JUSTIFICATION

REMOVAL OF INTERNAL CASEMENT WINDOWS

107 HIGH STREET, LINDFIELD, HAYWARDS HEATH, RH16 2HR

Recent photographs of the bin store

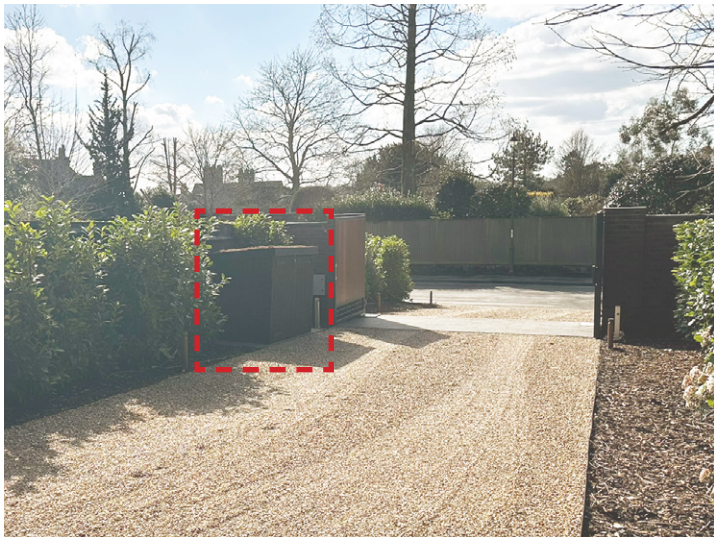
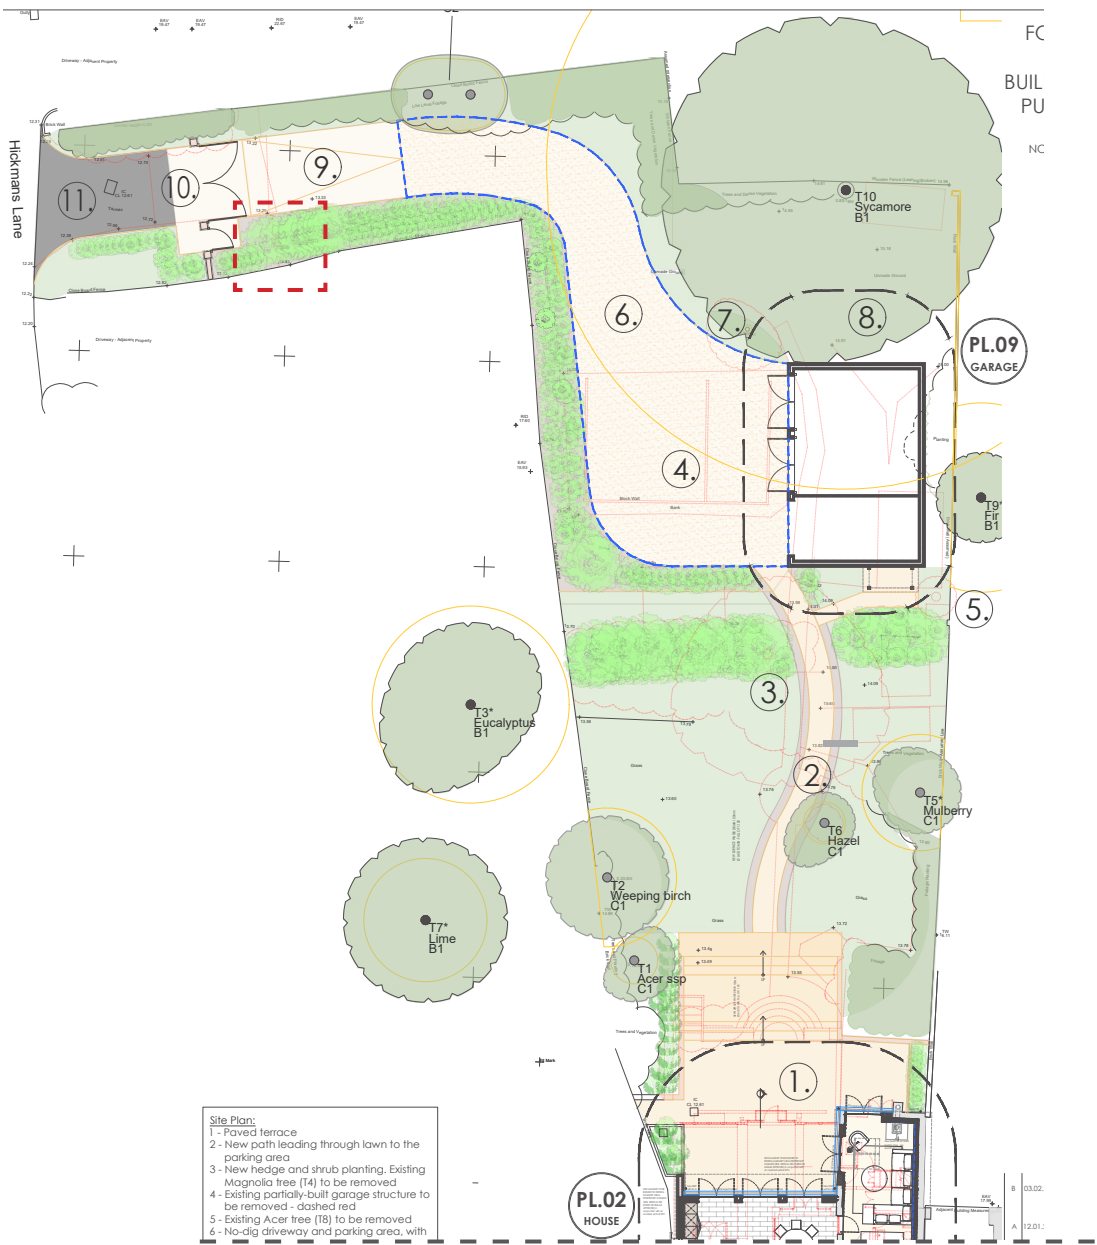
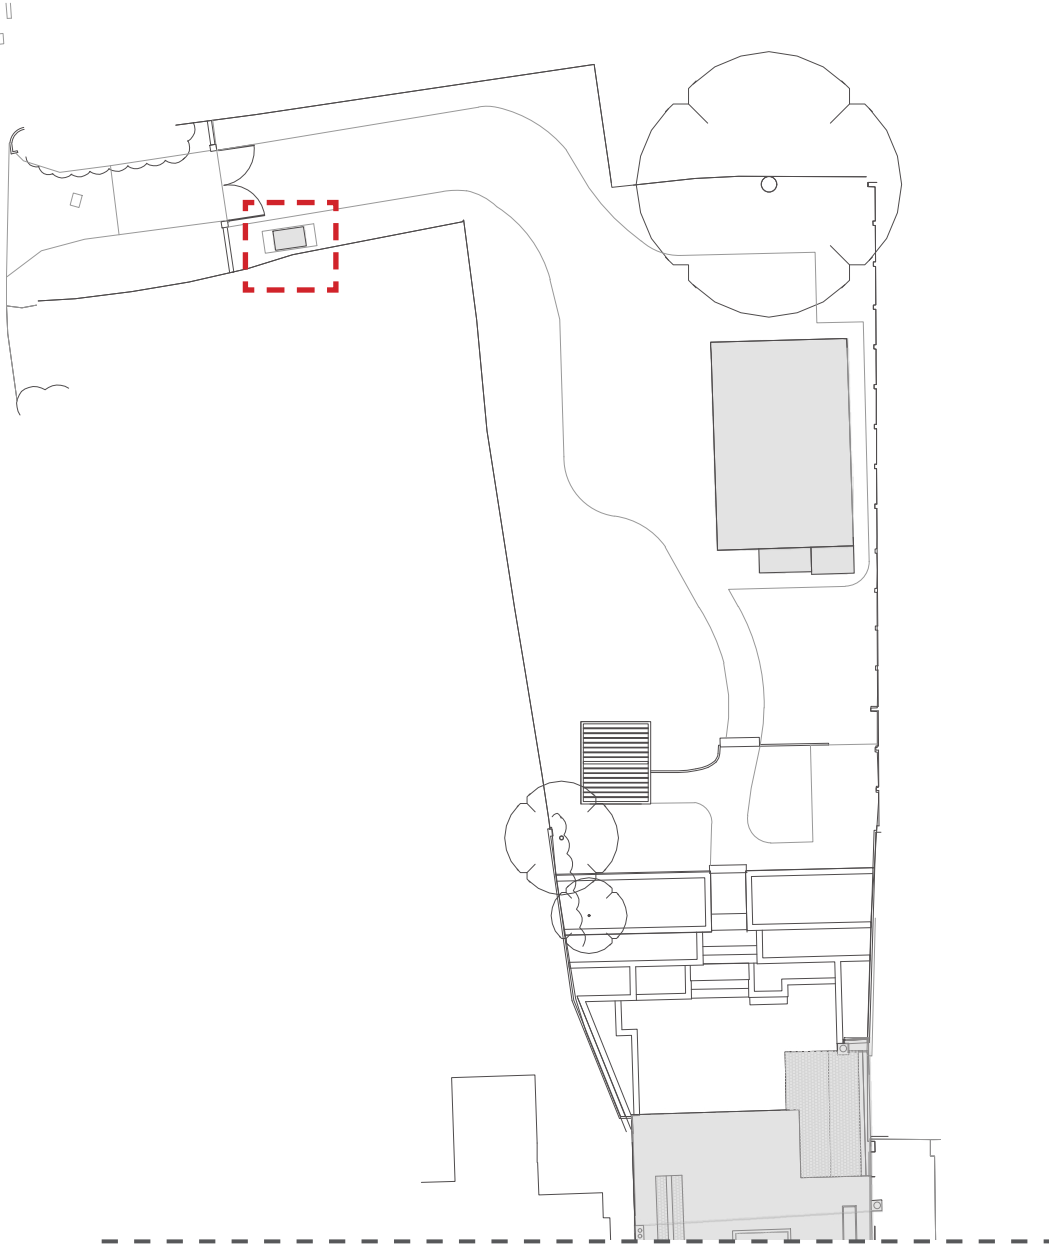
Timber bin store was constructed without planning permission and is a part of retrospective works applied for under this application.

The bin store is of a modest design and small size. Its materiality matches the garage. A green roof was introduced to further match the appearance of the garage building. The bin store is located in a significant distance from the listed building and tucked away within planting on a side of the driveway. This is a sensible solution serving the essential purpose of refuse storage. It is considered to be of low harm to the listed building and its settings as outlined in the supporting HCUK heritage statement.

Ornamental garden arch in Corten steel at entrance to garden

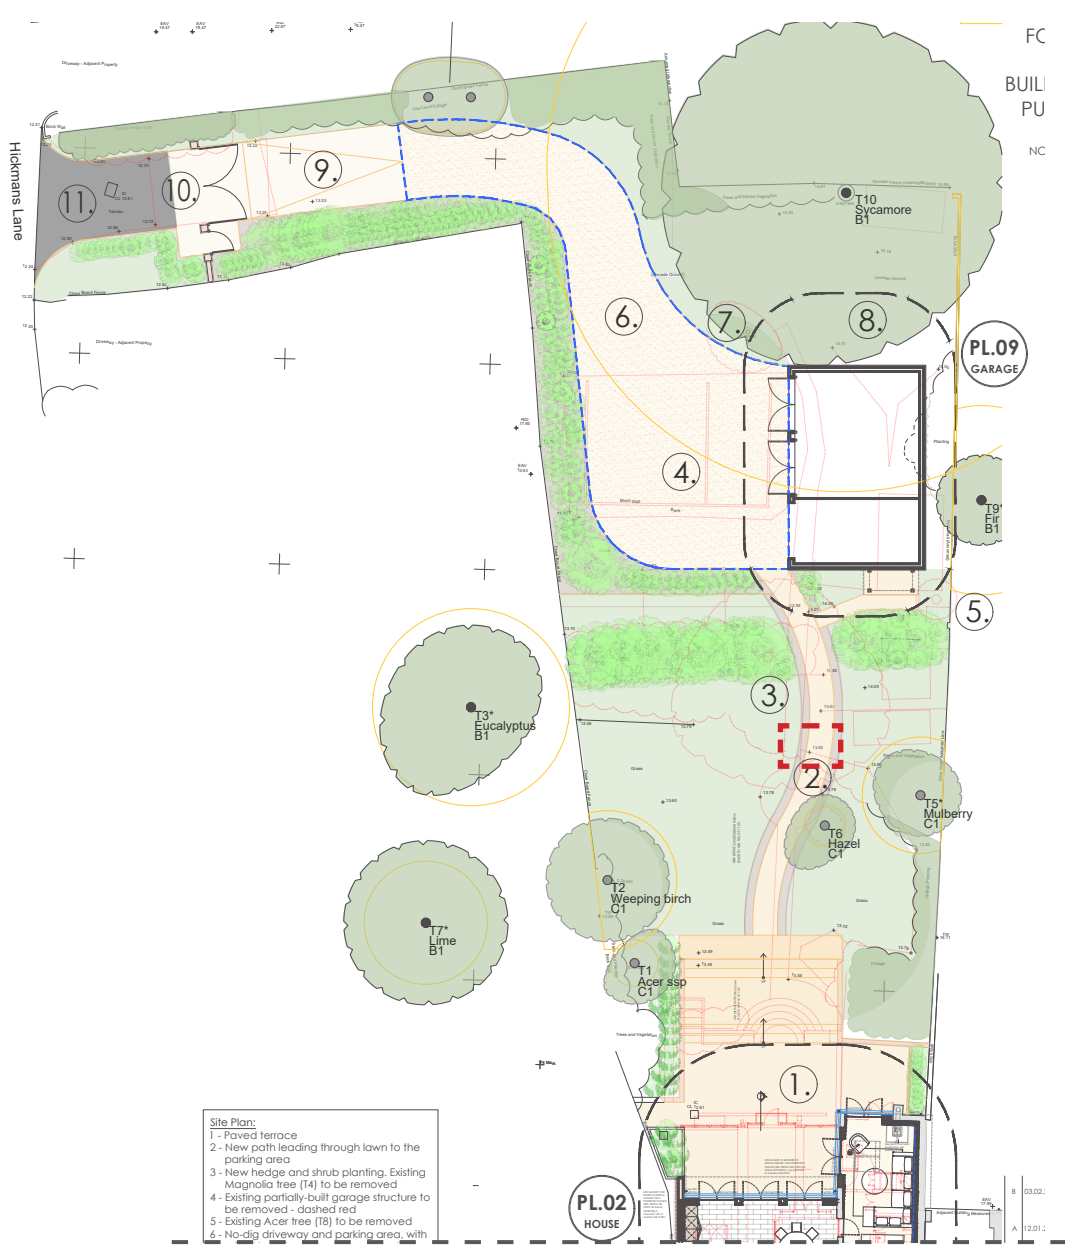
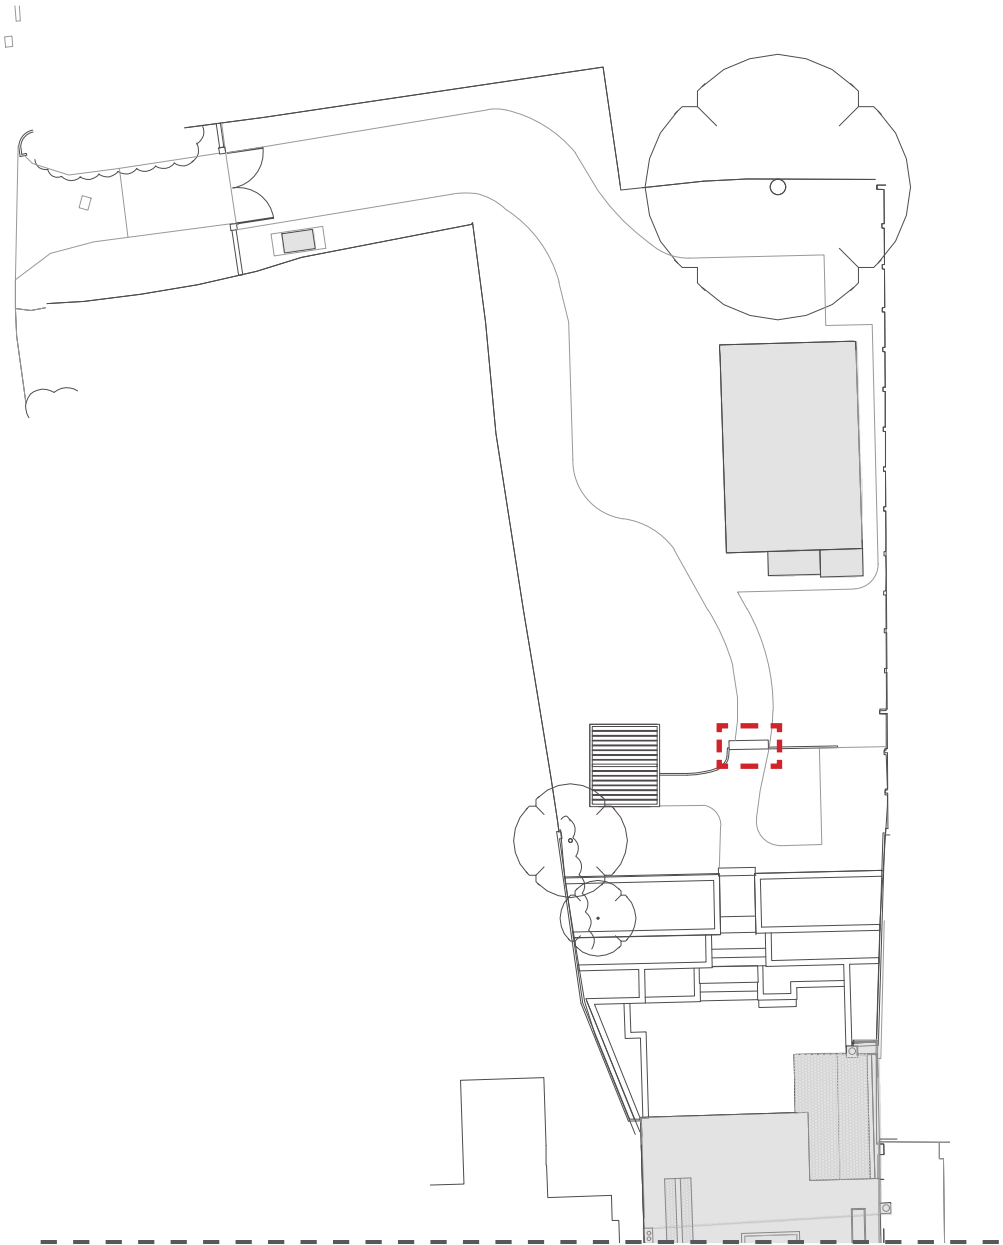
The ornamental arch in corten steel at the entrance to the garden has been constructed without planning permission and is applied for approval under this application.

In the supporting Heritage Statement, HCUK describes it as follows: ‘The feature Corten steel arch is an attractive contemporary addition to the landscaped garden and would have a neutral impact on the listed building’s significance.’

2. Proposed driveway gates

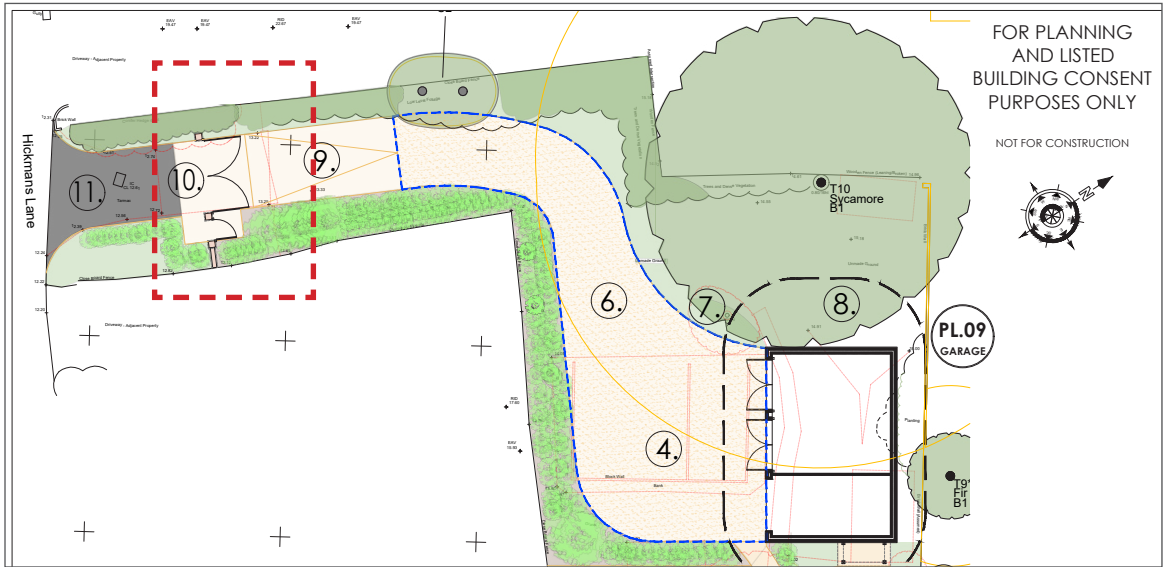
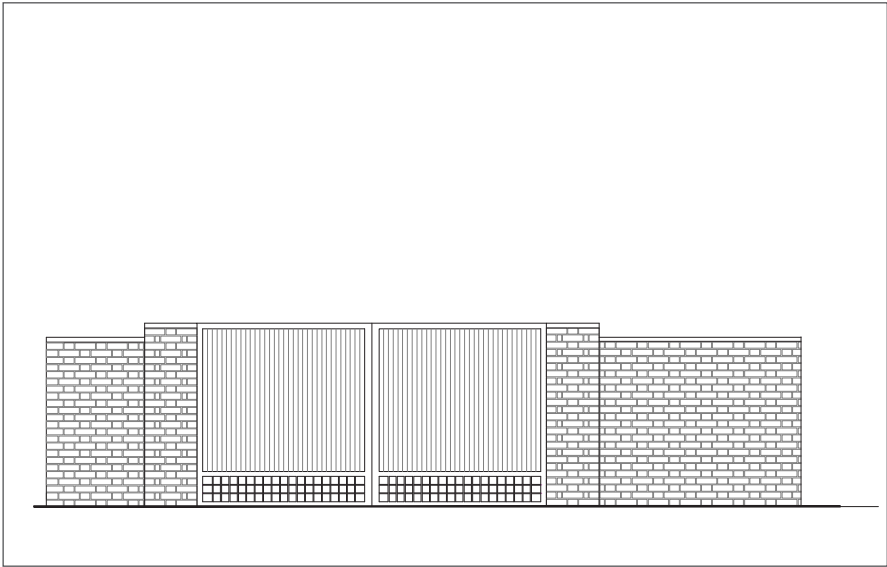
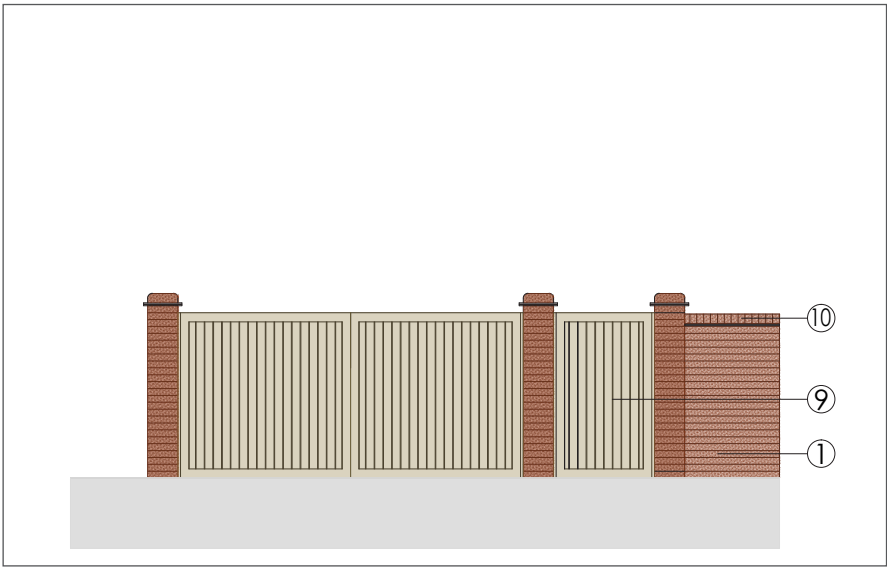
Different timber gates and brickwork piers to those in the approved scheme have been constructed, and are a deviation from the approved scheme. They are however of a modest design in keeping with the vernacular of the proposed detached garage building, and sympathetic to their Listed Building and wider Conservation Area setting, as outlined in the supporting HCUK heritage statement.

There is a lack of local planning guidance on vehicular gates and the high-quality materials and style are befitting of their setting, particularly as they are set back from the highway and flanked by vegetation that forms a visual break in Hickmans lane. Ultimately, they are metal gates with timber infill panels, a modern interpretation of traditional applications of these materials. As noted, the contemporary nature of these gates in the context of the approved contemporary extension and garage, both constructed using the same material palette, provides visual consistency across the site, underpinning the established discourse throughout the scheme of modern additions juxtaposed with the tactile characteristics of historic fabric, that has been painstakingly and sympathetically restored by expert craftsman.
